Dual-signature LLDP v120

Lennart Yseboodt

Philips Lighting – Research

June 21, 2017

Summary

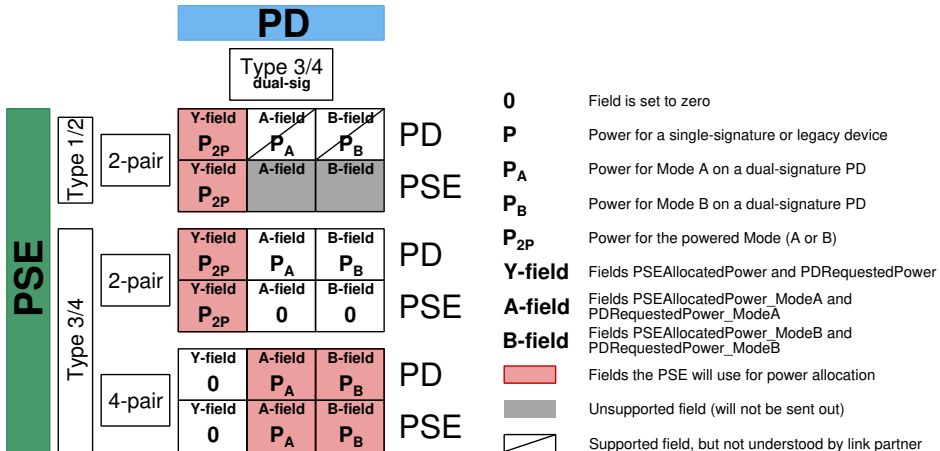
The core change compared to D2.5 is that fields that are not applicable, are set to zero. This prevents duplicate information being sent. Duplicate fields have potential to confuse.

Another change would be to allow dual-signature PDs to request power on a pairset that is unpowered. This is a valid use-case, currently disallowed by a requirement.

Plan is to provide normative requirement in one subclause on how to fill out the fields depending on the situation. State machines may need some tweaking to match with the desired behavior.
